Re: UE 394 – In the Matter of Portland General Electric Company, Request for a General Rate Revision.

Errata to CUB's Exhibits for Inclusion in the Administrative Record.

2019 Integrated Resource Plan.

Staff of the Public Utility Commission of Oregon (OPUC or Commission) submits these Opening Comments on Portland General Electric's (PGE or Company's) 2019 Integrated Resource Plan (IRP or Plan), filed on July 17, 2019 and Interim Transmission Solution Addendum filed on August 30, 2019. Staff will continue to evaluate the Company's Plan, conduct discovery, and review stakeholders' comments prior to submitting its Final Comments, currently scheduled to be filed on December 3, 2019.

FIGURE 7-13: Cost versus variability for the preferred portfolio

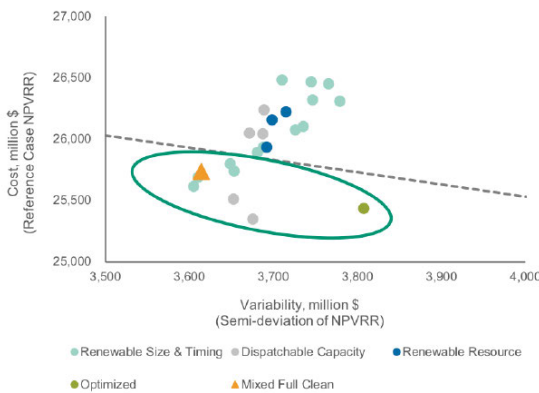
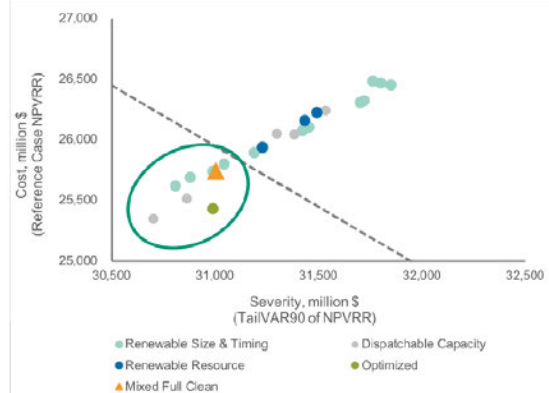
This approach to constructing a new preferred portfolio based on “reasonable actions” from other well performing portfolios is somewhat puzzling, and may present another blunt instrument in portfolio selection. Staff finds this approach particularly curious given that the Mixed Clean Full is outperformed by others in terms of cost and risk, as shown by PGE’s graphics:²⁰

PGE should provide an analysis comparing its preferred portfolio to other top-performing portfolios for cost and risk, and explain why the Company believes it has chosen a portfolio with the best balance of cost and risk, as required by the IRP guidelines.

Recommendation 4: As PGE adjusts its IRP analysis in accordance with Staff's comments, including the removal on non-traditional screens, PGE should provide additional information:

- Provide a quantitative comparison of its preferred portfolio to other well-performing portfolios in terms of NPVRR cost and risk.
- Explain why the Company believes its preferred portfolio has the best balance of cost and risk for customers.

PGE’s Intergenerational Analysis²²

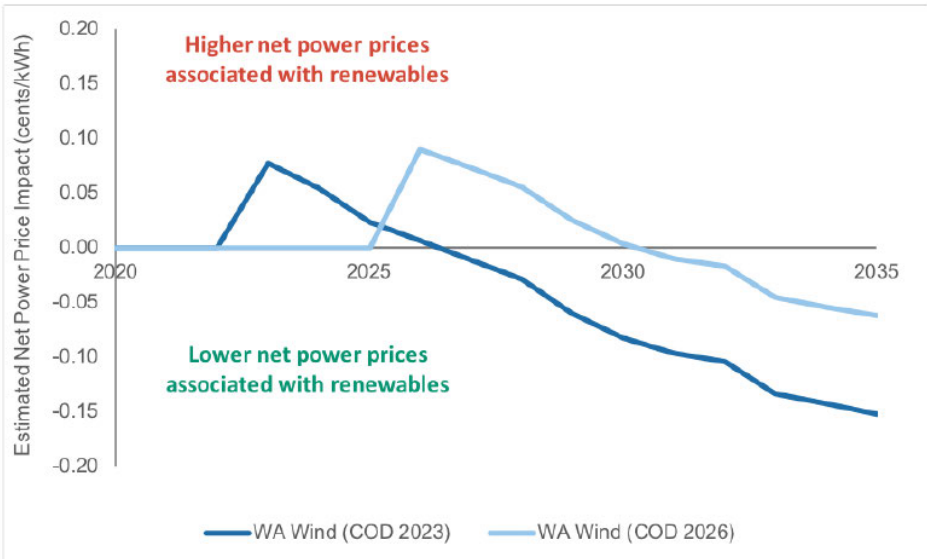
To place additional context on the analysis of a 2026 wind addition, PGE’s Appendix G Load Resource Balance indicates that PGE may have an energy deficit by 2025.²³ Staff will conduct additional analysis to consider how the 0.01 cent difference in customer rates compares to the risk of an energy need in 2025, given other assumptions about load growth, voluntary programs, and new Qualifying Facility (QF) contracts that are discussed elsewhere in Staff opening comments.

Many factors could change the effect that a new resource will have on rates, including resource cost and performance, future market conditions, and future customer demand. Staff will continue to assess the inputs and assumptions behind PGE’s intergenerational equity analysis. For example, the intergenerational equity analysis may utilize some of the same modeling inputs and assumptions that Staff finds concerning or problematic in the 2019 IRP. Staff hopes PGE will participate in a robust assessment and discussion of the intergenerational equity risks of near-term procurement of renewables.

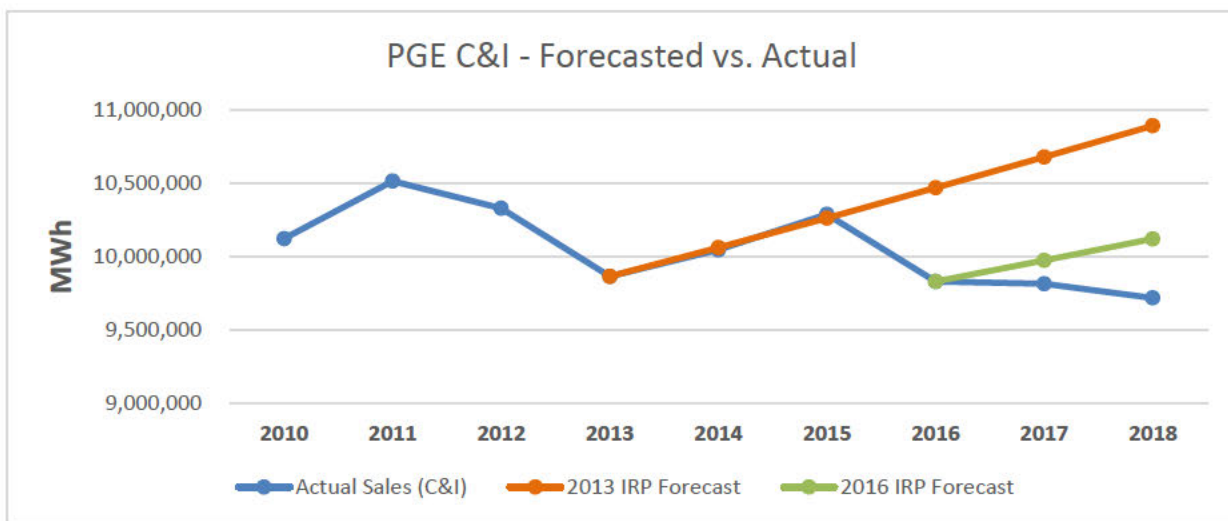
As Staff works with the company on this reconstruction of PGE’s work, Staff is has noted a few new issues with its load forecast. PGE’s rates of projected load growth by customer class in this IRP are modest:

Yet, based on recent trends, Staff is unsure of the accuracy of this IRP’s commercial and industrial load forecasts. Below is a comparison of actual load since 2010 and previous IRP forecasts:⁵²

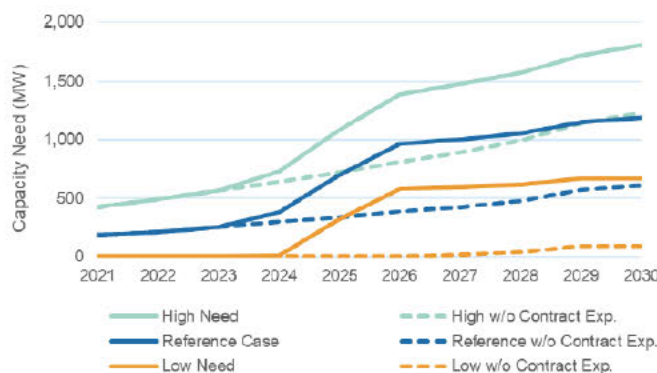
Staff is currently reviewing the forecasted range of capacity needs in the 2019 IRP, which it finds is strikingly broad. Staff is motivated to ensure that the Company gives adequate considerations to capacity adequacy, particularly given the robust discussions in Chapter 3 Futures and Uncertainties and the regional capacity need shown by recent studies evaluated in the Market Capacity Study.⁵⁹

PGE forecasts wide “jaws” of capacity need by 2025, ranging from a low of 0 MW to a high of nearly 1,100 MW of new capacity. The graphic below captures the wide range of possible need.⁶⁰

FIGURE 4-17: Load and existing and contracted generation

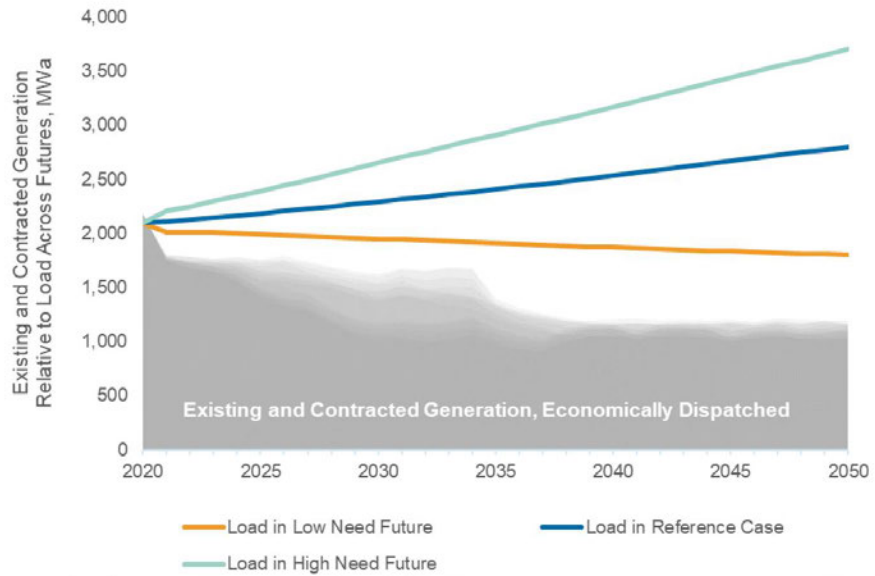
PGE’s new market energy position analysis provides an interesting evolution of the Company’s traditional load-resource balance. Through this analysis, PGE models economic dispatch and compares it to three need futures to demonstrate what it describes as an “energy shortage” (See Figure 4-17).⁶⁶

Yet, when PGE’s resources dispatch economically and market purchases meet the rest of PGE’s load, this is not necessarily an indication that PGE needs to acquire more energy resources. It may simply indicate that market prices are low. PGE’s ‘Market Energy Position’ analysis tells how much energy the company may choose to buy on the market, but in no way should it be used to justify any amount of new resource acquisition.

FIGURE 6-2: Levelized cost of energy (LCOE) of energy resource options

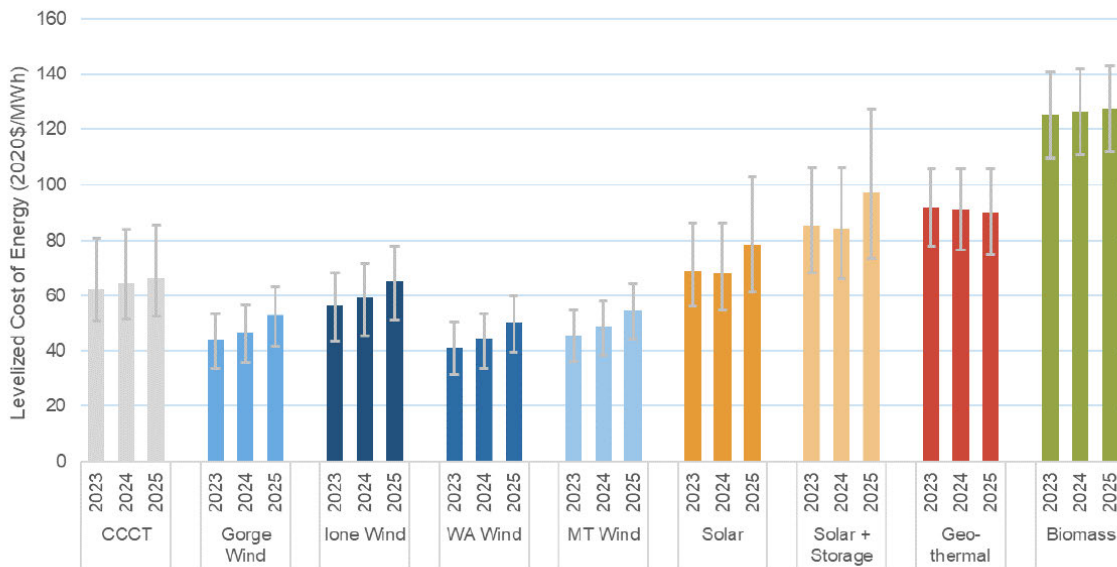
Staff finds this statement generally true and believes the IRP does a good job of demonstrating the production risk associated with capacity factor sensitivity in Section 6.5.⁸² However, Staff would like to better understand how the many assumptions underlying this conclusion were captured in the portfolio modeling and selection. Given that the main driver for the near-term acquisition of wind resources is not energy, capacity, or an RPS need, but rather the time-limited economic opportunity associated with expiring PTCs, Staff’s review is focused on understanding the Company’s assumptions around the federal tax incentives and overall performance of renewable energy resources compared to conventional resources (See Figure 6-2 below).⁸³

FIGURE 6-15: Net cost sensitivities for wind

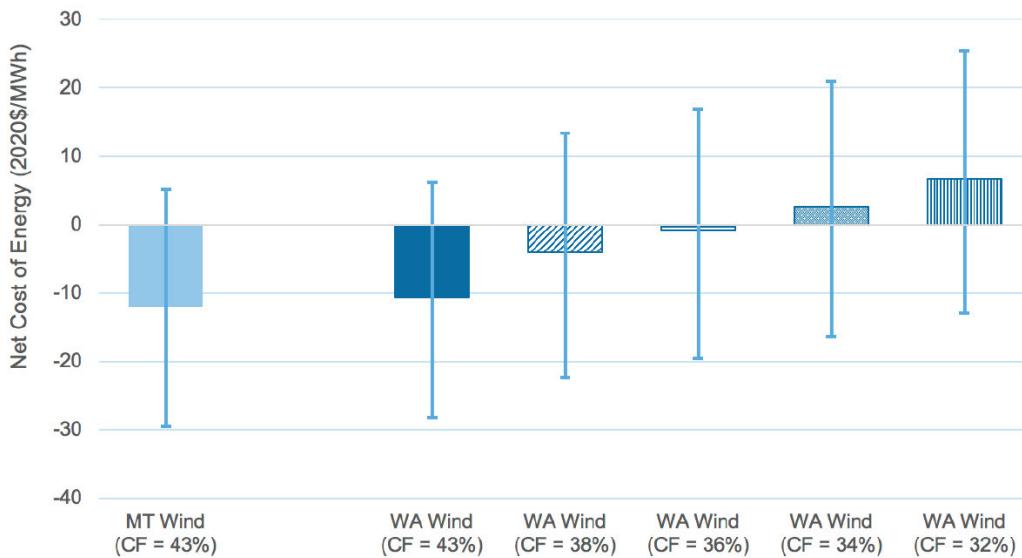
Staff particularly appreciates the sensitivity analysis for wind capacity factors provided in Section 6.5 and Figure 6-15 below.⁸⁹

Staff notes the impact that capacity factor assumptions have on the economic performance of wind resources in PGE’s sensitivity and questions whether the Company’s sensitivity analysis should have been performed on the Mixed Full Clean portfolio to help characterize the risk of acquiring near-term wind assets based primarily on economic performance.

Recommendation 20: Staff requests that PGE provide a sensitivity analysis of the Mixed Full Clean portfolio assuming proportionate changes to the capacity factor of each resource as the assumptions behind the capacity factor sensitivity analysis in Figure 6-15 above.

FIGURE 5-4: Average monthly wind capacity factors by location

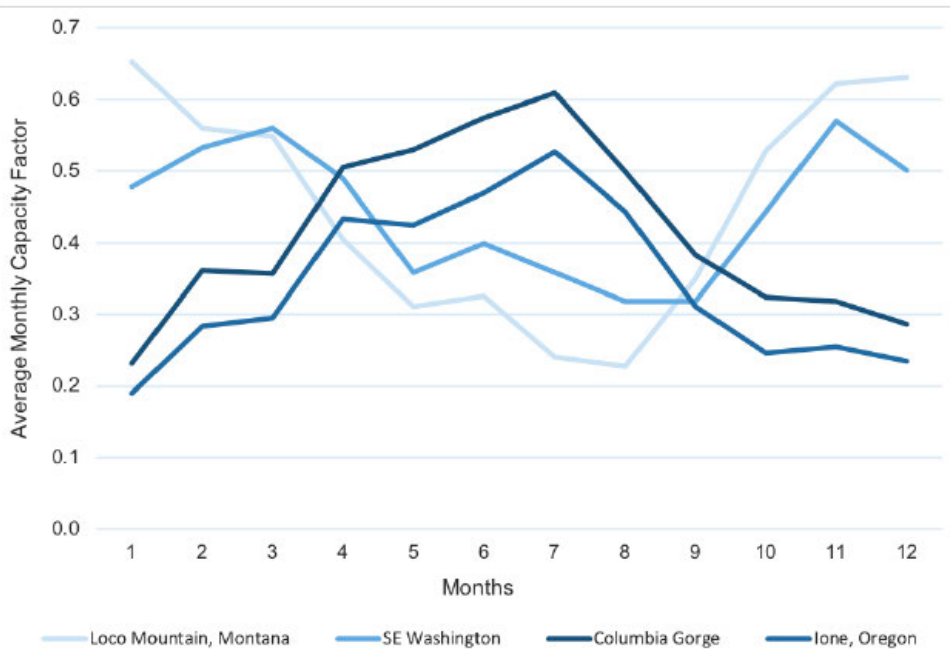
Further, Staff is curious about the relationship between the capacity factor shape of different wind resources modeled in the IRP and PGE’s projected capacity needs. For example, PGE provided a helpful characterization of different wind resources’ capacity factor shapes in Figure 5-4.⁹⁰ Staff notes that the performance of Columbia Gorge and Lone, Oregon wind follow the reverse shape to that of Montana and Washington wind.

FIGURE 4-14: Reference Case loss-of-load expectation in 2025

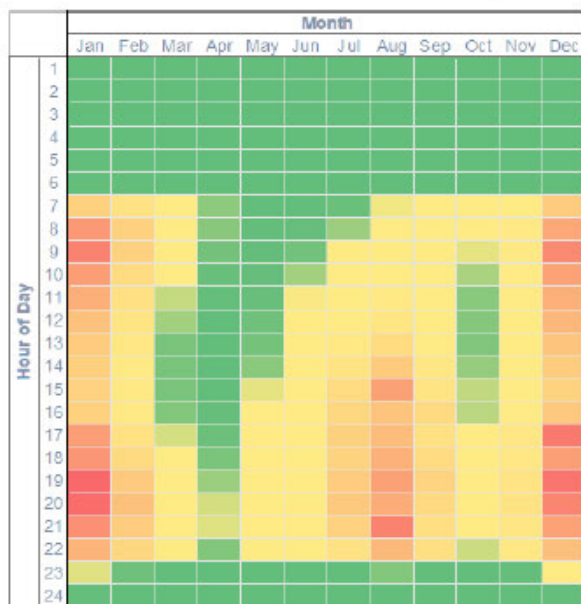
Given the Action Plan’s lack of specificity regarding resources in the renewable RFP and the future capacity actions, it is particularly interesting to note the relationship between the wind shapes and PGE’s characterization of its capacity need found in figure 4-14.⁹¹
